Spokane Design Review Board

Wednesday, April 24, 2024

5:40 – 6:45	4) Spokane County Operations Complex – Recommendation Meeting	Dean Gunderson
	<ul style="list-style-type: none">• Staff Report Presentation• Applicant Presentation• Public Comments• Board Discussion

Since our last meeting the Spokane County Operations building has progressed significantly. Both the buildings and site have been developed to show materiality and character which you will see represented in the Design Review Board comment responses on the following pages.

NORTH / SOUTH SITE CROSS SECTION

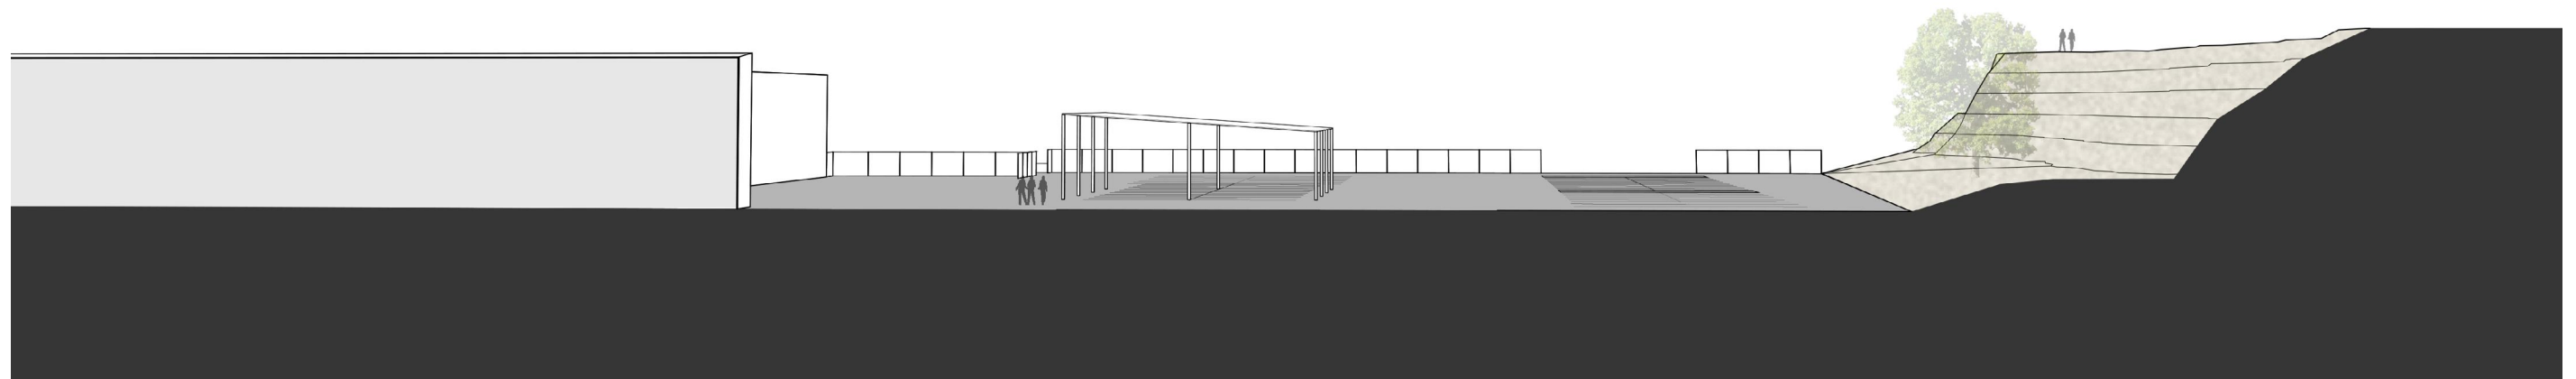
- 6. Landscape Screening Along Northern Property Line** – Based on the north/south site section illustration provided by the Applicant, the Development Services Center finds any required landscape screening along this property line has been sufficiently meet with the adjacent grade change.

9. The Applicant is encouraged to return with site sections that further explain the landscape screening and buffering along the north property line.

The applicant will develop site sections and review landscape buffering for alternatives that may better address the needs of the public and surrounding properties.

Advisory Action 2

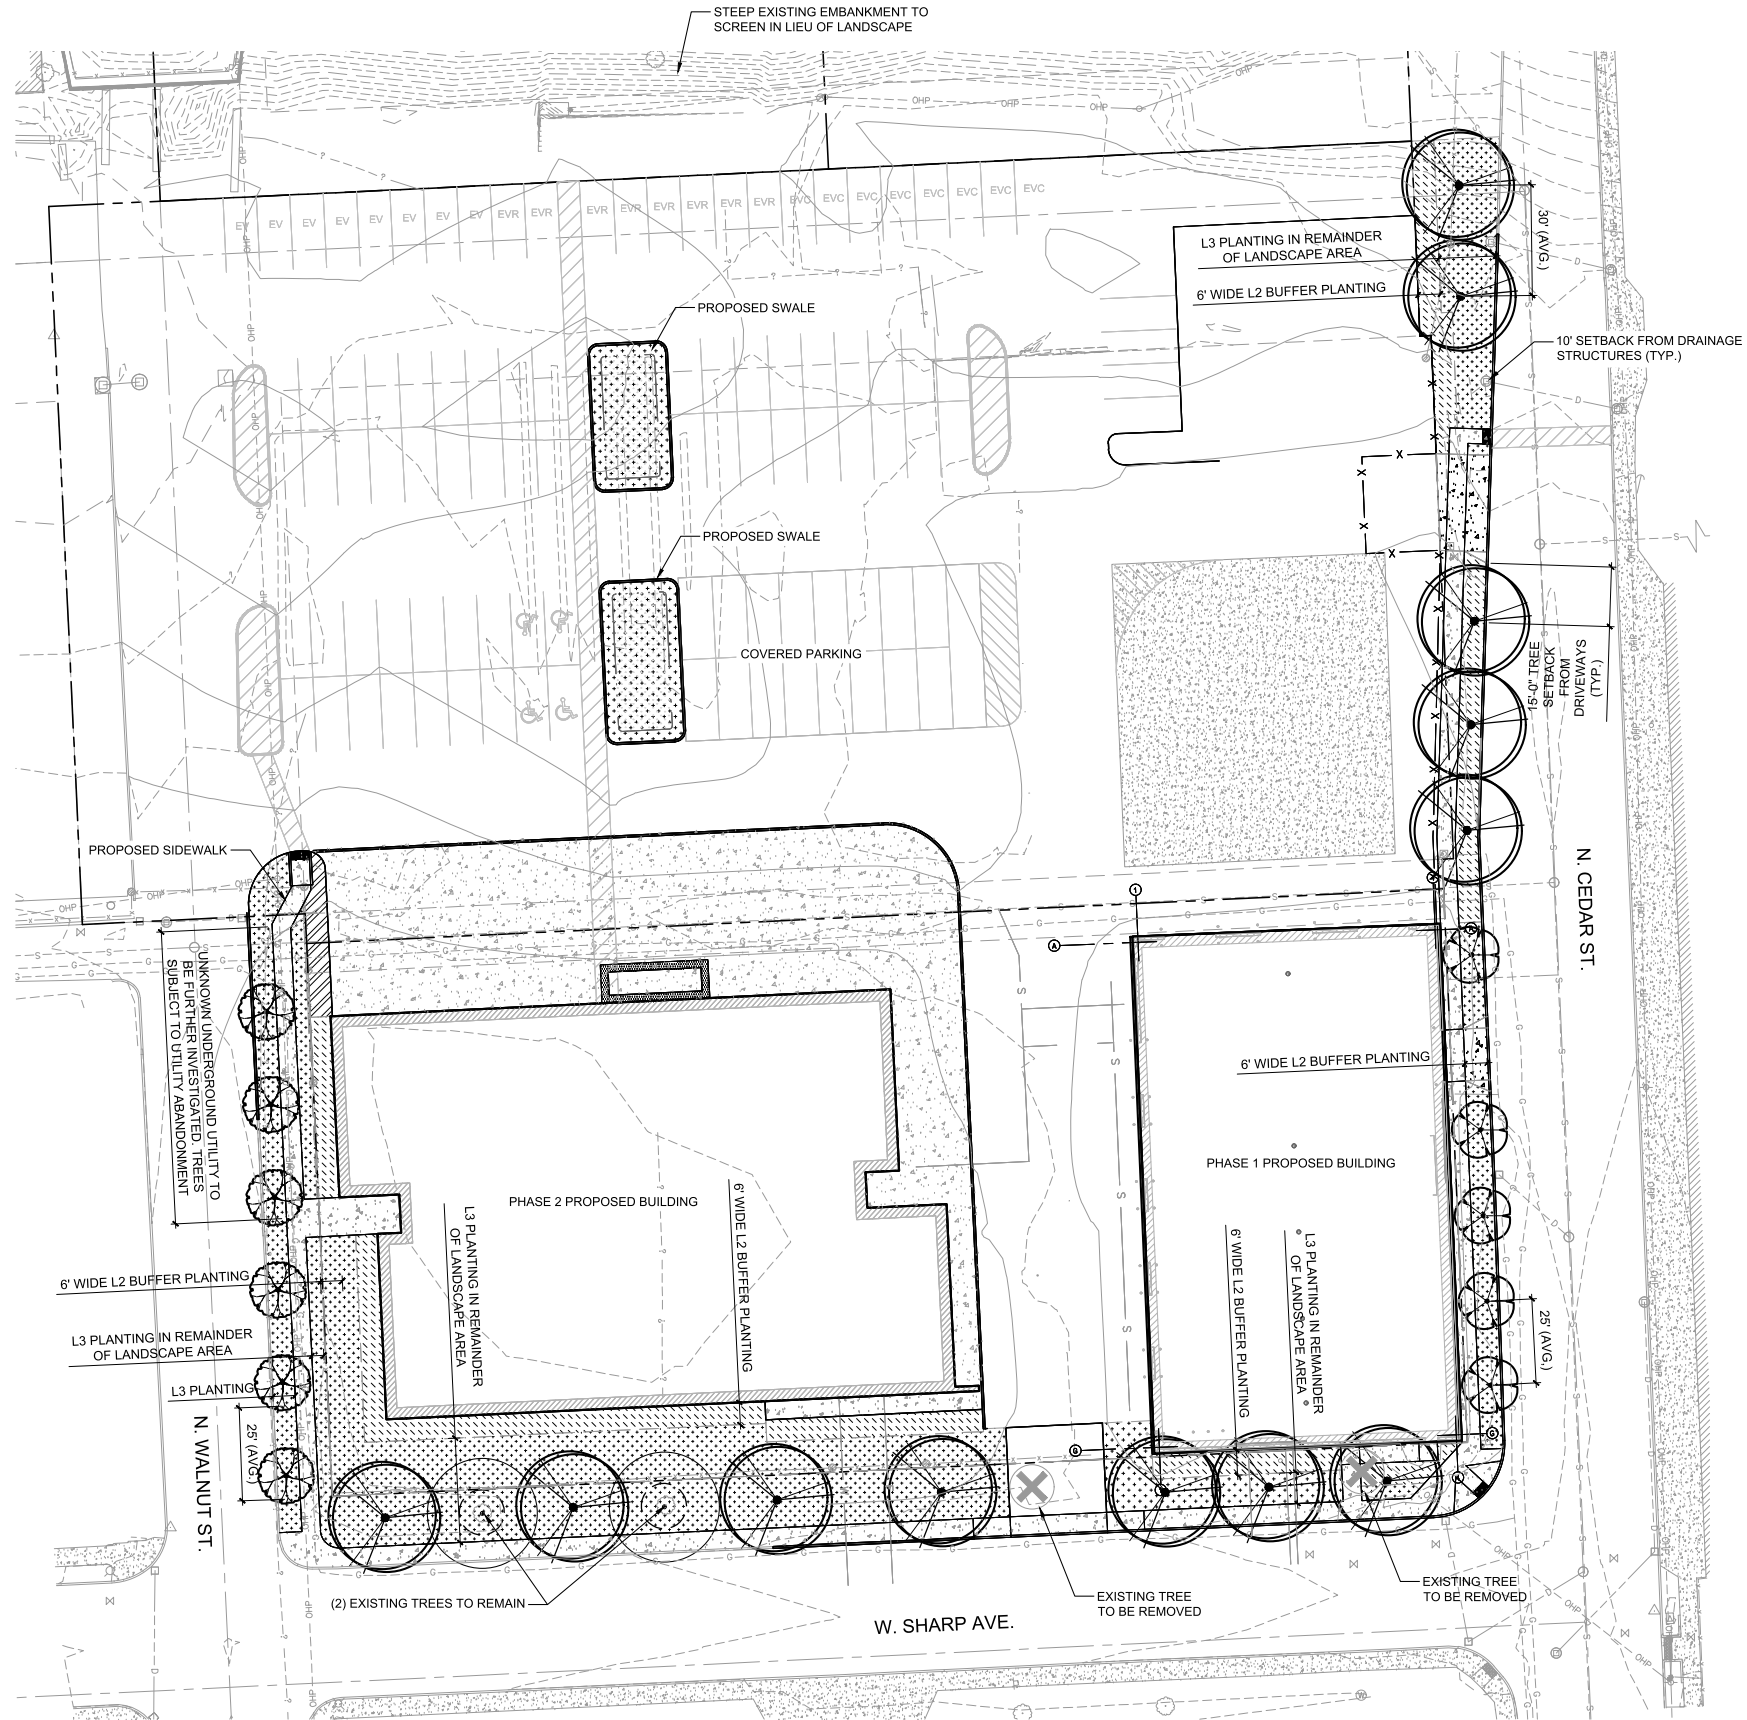
The new Street Trees along Walnut Street should be planted in the 6'-wide landscape strip located between the sidewalk and the street curb. Due to the presence of overhead power transmission lines, these Street Trees would be limited to Class I species.

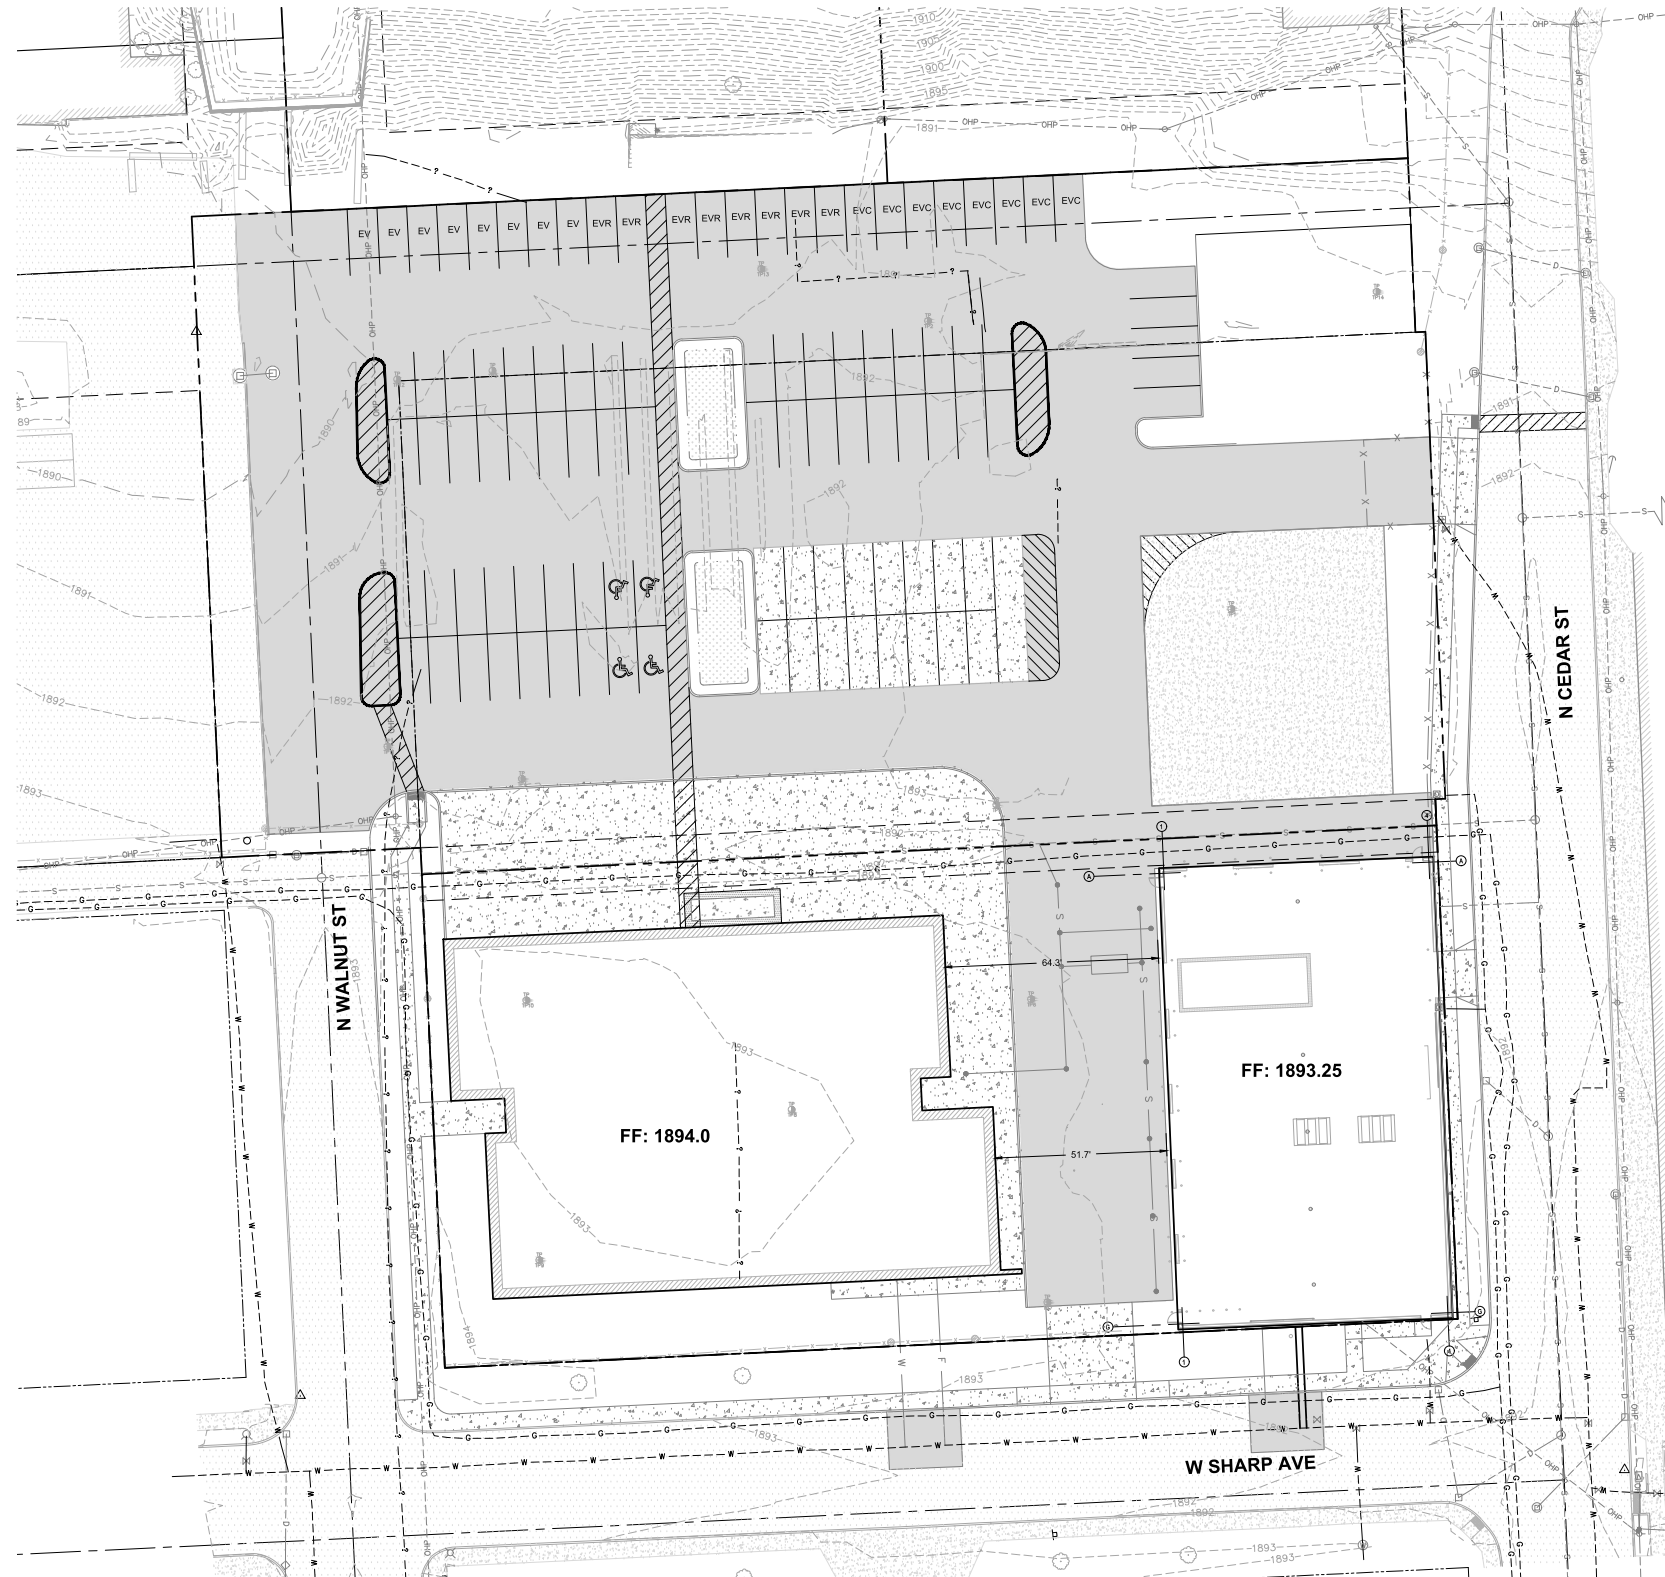
As the multiple curb-cuts and broken sections of existing sidewalk along Cedar Street will need to be replaced, a new 5'-wide sidewalk along the Subject Site's Cedar Street frontage should be constructed behind a 6'-wide continuous landscape strip.

Advisory Action 4

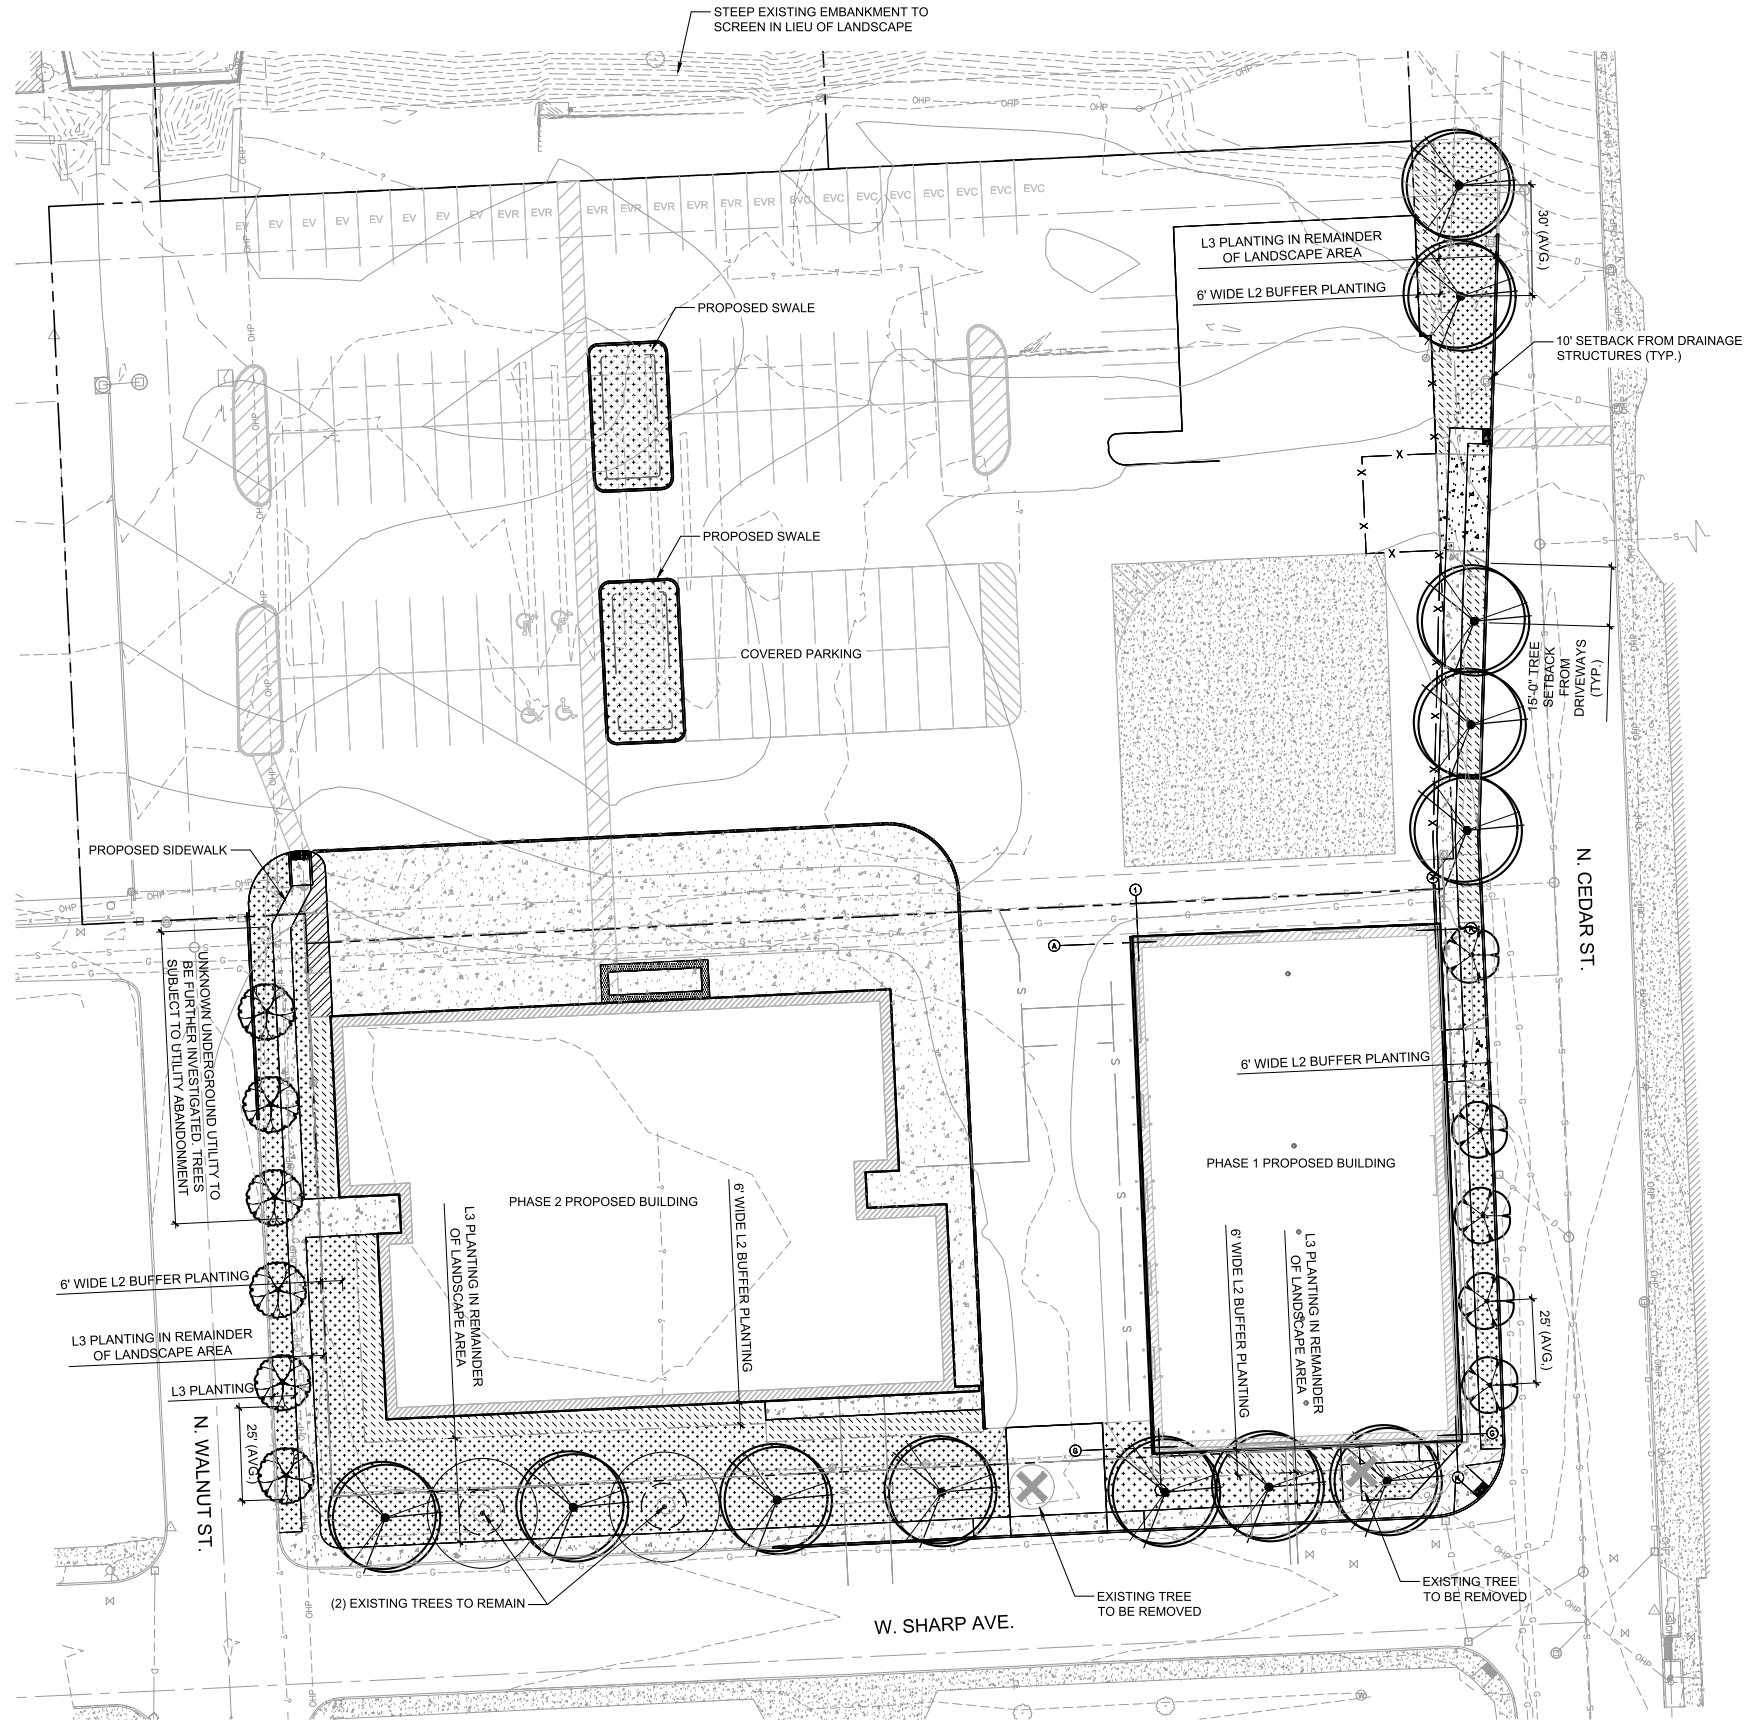
The new Street Trees along Cedar Street should be planted in the 6'-wide continuous landscape strip. All new Street Trees must be selected from the Class II category.
